Development Review Board NOTICE OF PUBLIC MEETING AGENDA

MEMORANDUM

To: DRB, SB
From: Underhill Planning and Zoning
Date: 4/4/2016
Re: Agenda and Information for 4/4/16 Hearing

**Final Hearing on the Application of
The Linda G. Rondeau Family Trust for a revision to the 2005 Vaughan Subdivision**

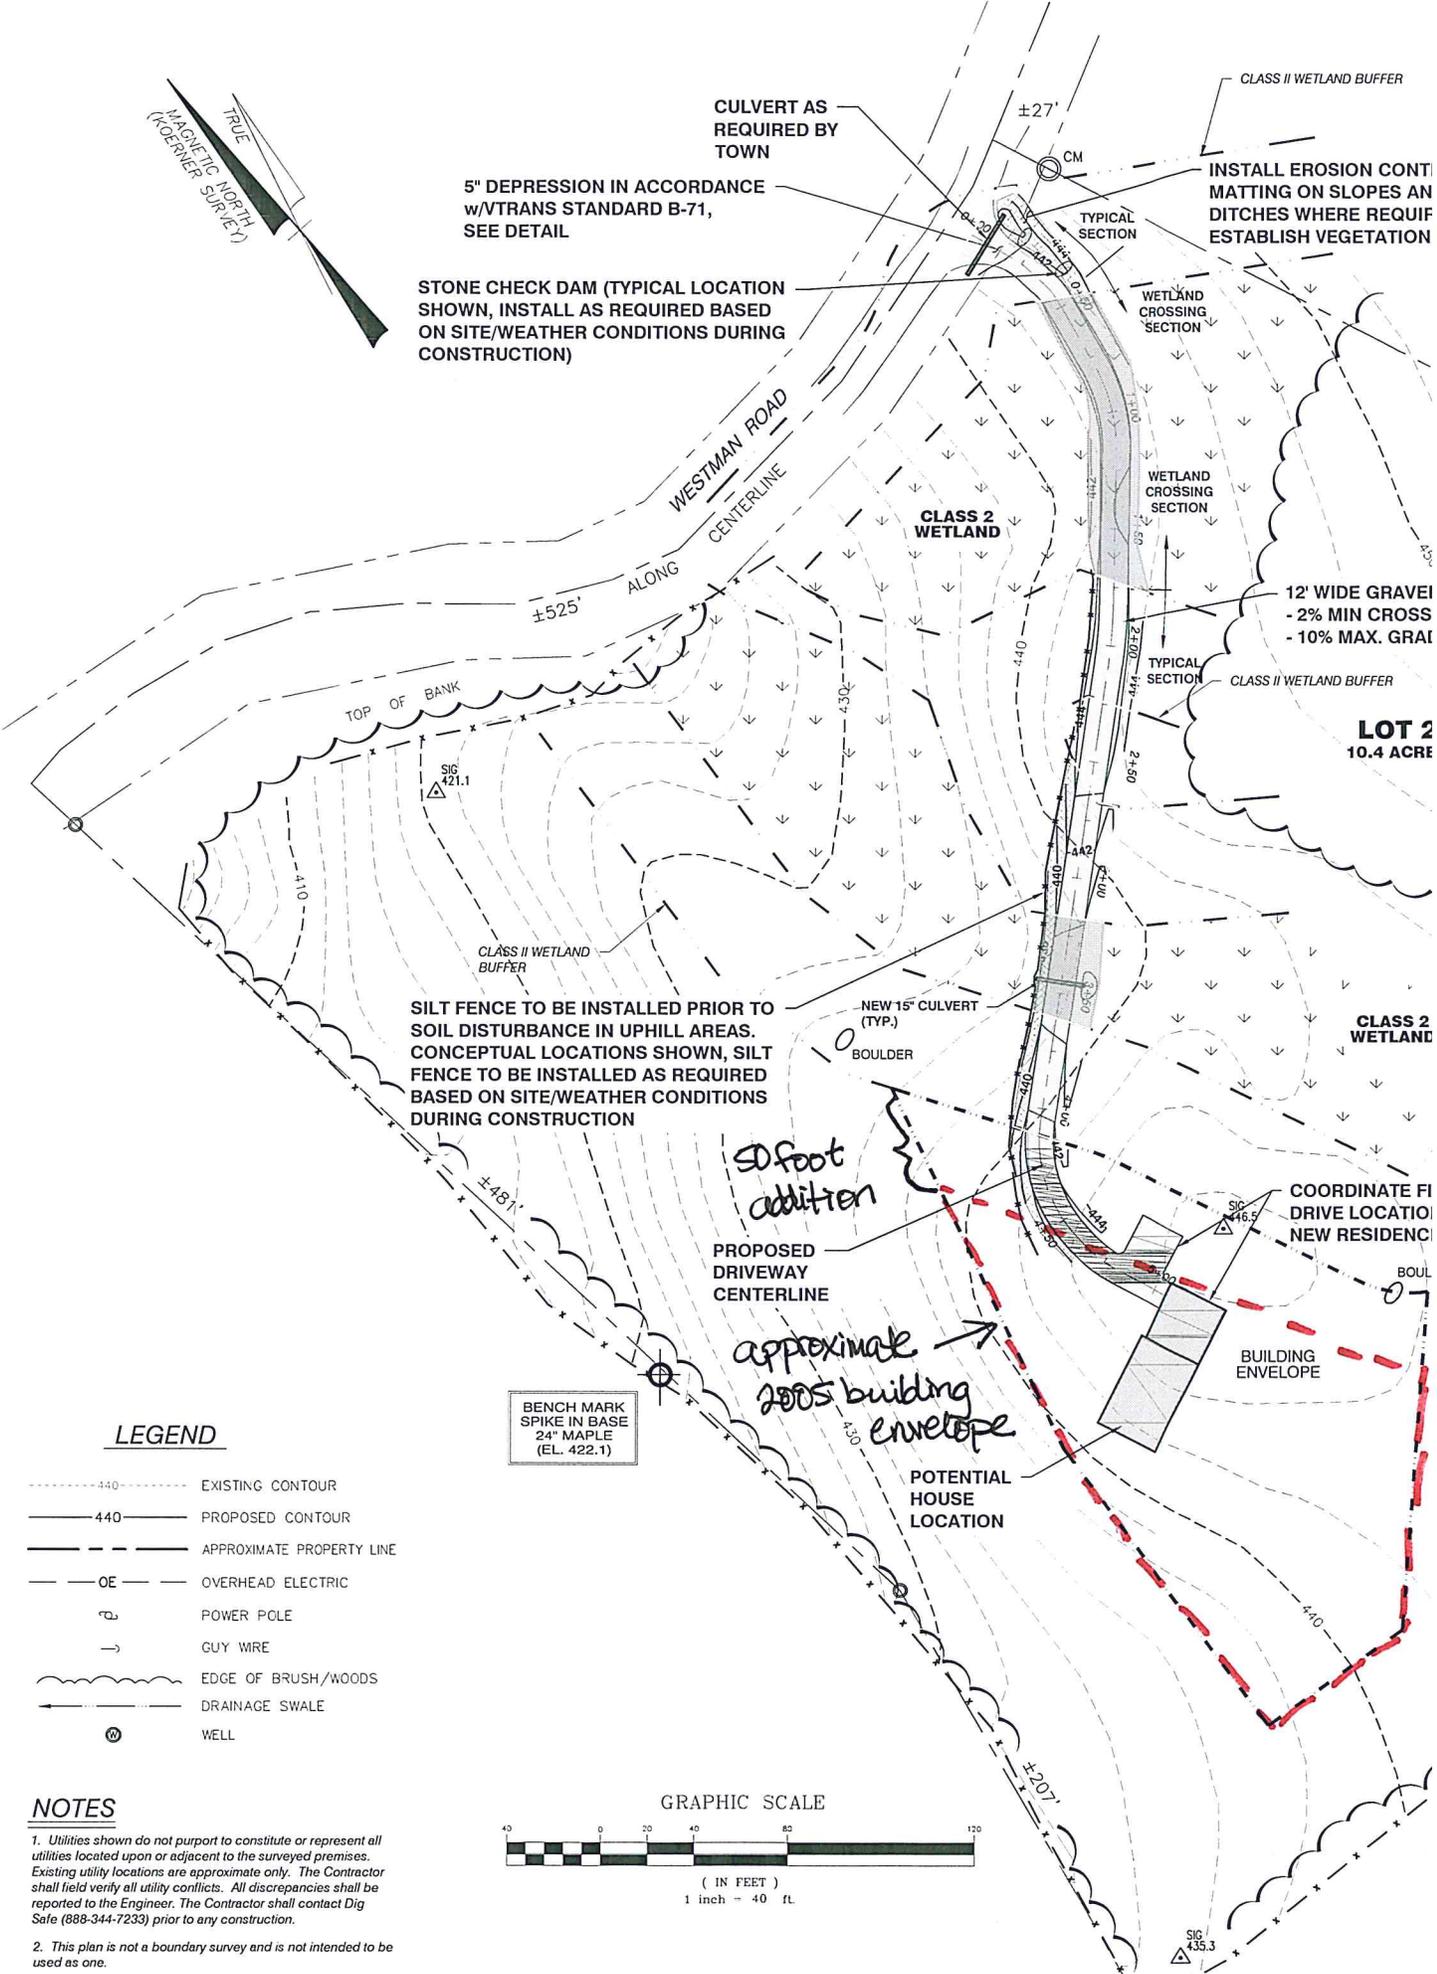
The zoning regulations require that all new driveways must meet the requirements of Section 3.2 and the Town Road Policy. Section 3.2 requires that driveways (serving up to 3 lots) meet B-71 standards. The driveway, as shown in the attached driveway grading plan and erosion control details and specifications, prepared by Civil Engineering Associates, appears to meet these standards.

Section 3.2(9)(b) states that driveways “shall be located to avoid, to the extent physically feasible...primary agricultural soils and surface waters, wetlands and associated buffer areas...” Though the driveway will impact the Class II wetlands on the property, the applicant has received an Individual Wetland Permit (2014-217) from the Vermont Department of Environmental Conservation for the driveway as proposed.

Additionally, much of the lot contains primary agricultural soils of statewide significance (map attached). However, it is impossible to access the building lot as proposed without impacting these soils.
